**STAFF RECOMMENDATION**

**1104 Halcyon Avenue**

**May 18, 2016**

**Application:** New construction – outbuilding; Setback determination  
**District:** Waverly-Belmont Neighborhood Conservation Zoning Overlay  
**Council District:** 07  
**Map and Parcel Number:** 11801013700  
**Applicant:** Hudson Walker  
**Project Lead:** Sean Alexander@nashville.gov

**1 FIRST FLOOR PLAN**  
1/4"=1'-0"

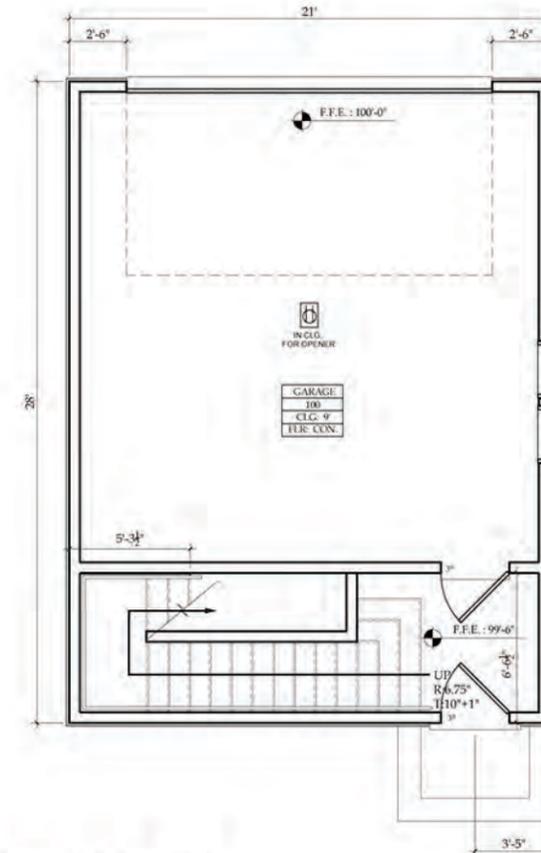
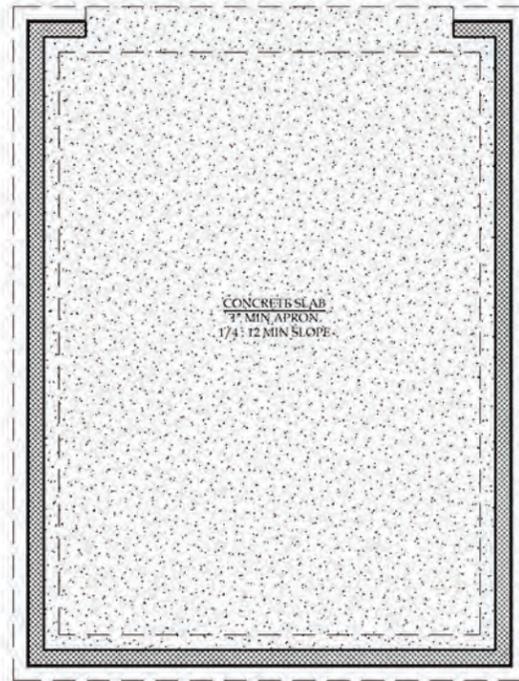
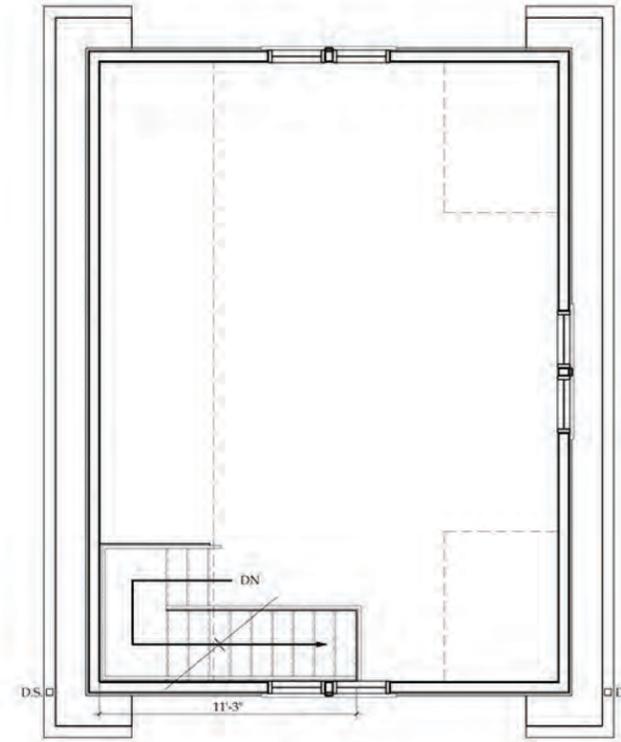
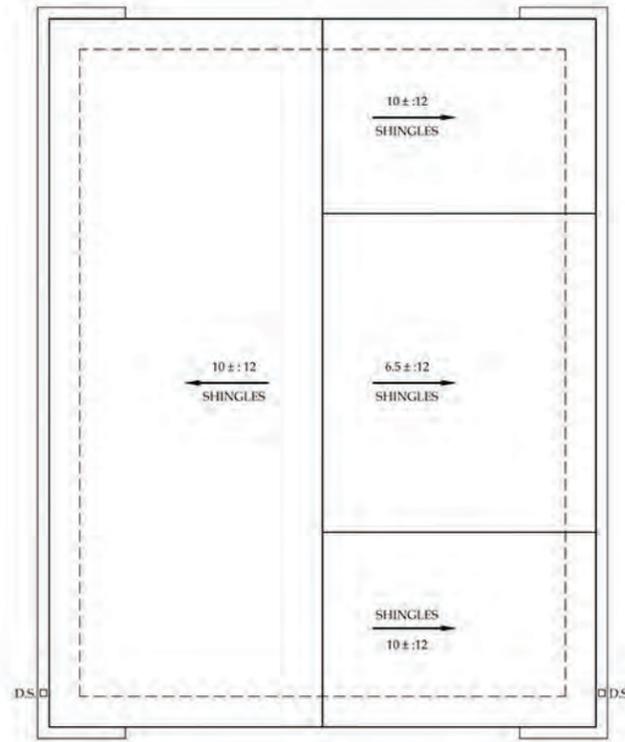
The outbuilding will be twenty-one feet (21') wide and twenty-eight feet (28') deep, giving it a five hundred, eighty-eight square foot (588 sf) footprint. This footprint will be less than half the area of the footprint of the historic house, which is appropriate and would meet section III.H.1 of the design guidelines for outbuildings.

1 FRONT ELEVATION  
 1/4"=1'-0"

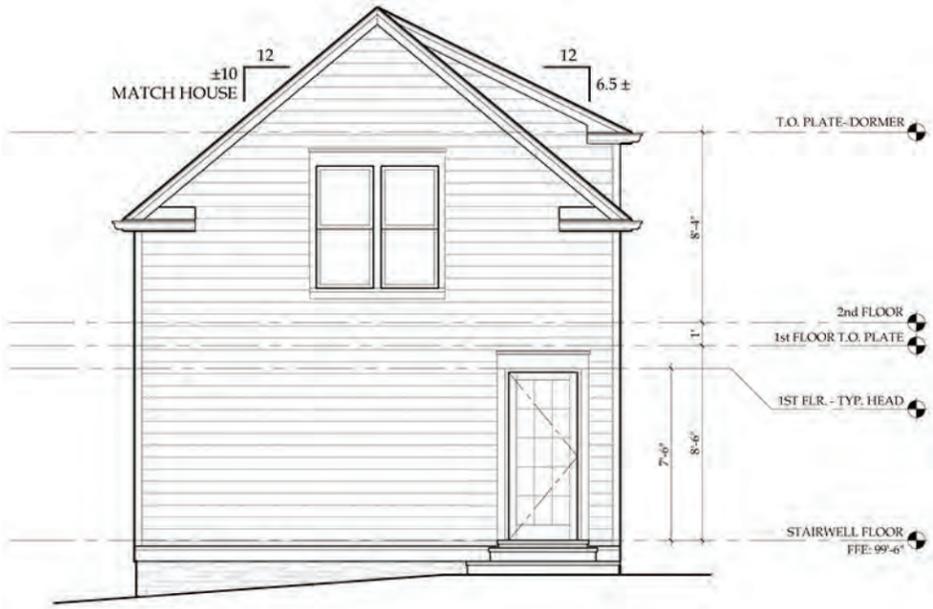
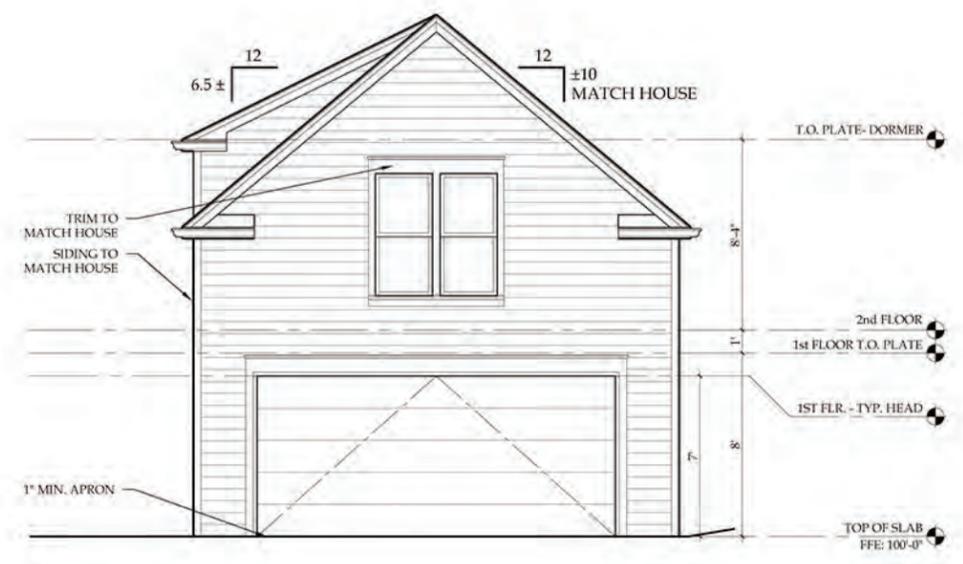
Height & Scale: The roof height of the proposed outbuilding, averaged from the grade, would be twenty-four feet (24') and the eave height would be fifteen feet (15'). The roof height for the historic house, by comparison, is twenty-nine feet (29') with an eave height of fourteen feet (14'). This includes approximately four feet (4') of foundation above grade. Section III.H.1 of the design guidelines state that the ridge and eave heights of outbuildings should not exceed the corresponding heights of their principal building, up to a maximum of twenty-five feet (25') for ridge height and ten feet (10') for eaves. Staff finds the height of the eaves on the proposed outbuilding to be inappropriate and to not meet section III.H.1 of the design guidelines.

Roof form: The primary roof of the outbuilding will be a front-oriented gable with a pitch of 10:12, matching the roof of the house. There will be a shed dormer on the right slope of the roof with a 6.5:12 pitch. The dormer will stack directly over the wall of the first story. While section III.H.3 of the design guidelines requires dormers to sit back two feet (2'), this façade of the building faces the interior of the lot and will therefore be obscured behind the principal building. For those reasons, Staff finds the roof form to be compatible. Staff finds the roofs of the proposed outbuilding to be compatible with those of the principal building and to meet section III.H.3 of the design guidelines.

Note: The outbuilding is not proposed to be a Detached Accessory Dwelling Unit. Under Section 17.16.030 of the Metro Code it could not be converted to one because it would not meet the standards for a DADU if the dormer does not sit back two feet (2').

Because lowering the eave heights could dramatically change the slope of the roof and/or the plans for the interior, staff recommends disapproval rather than an approval with conditions.
